## **Addendum 5: Regulation No. 6**

### **Revision 4 – Amendment 4**

Supplement 19 to the 01 series of amendments: Date of entry into force: 19 August 2010

### **Uniform provisions concerning the approval of direction indicators for power-driven vehicles and their trailers**

Annex 2,

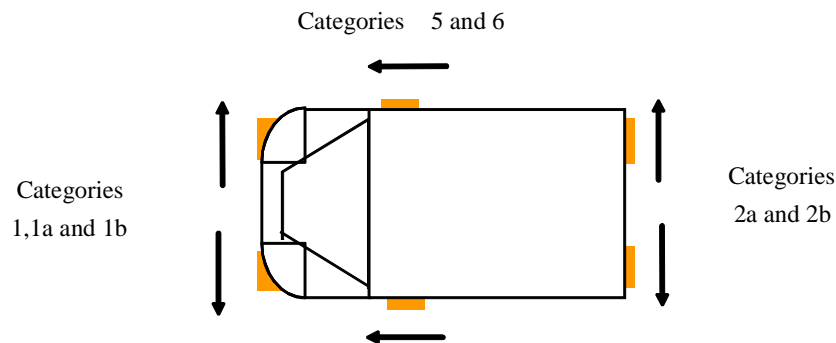
Item 9, amend to read:

“9. Concise description:  
....  
Category: 1, 1a, 1b, 2a, 2b, 5, 6<sup>2</sup>  
....”
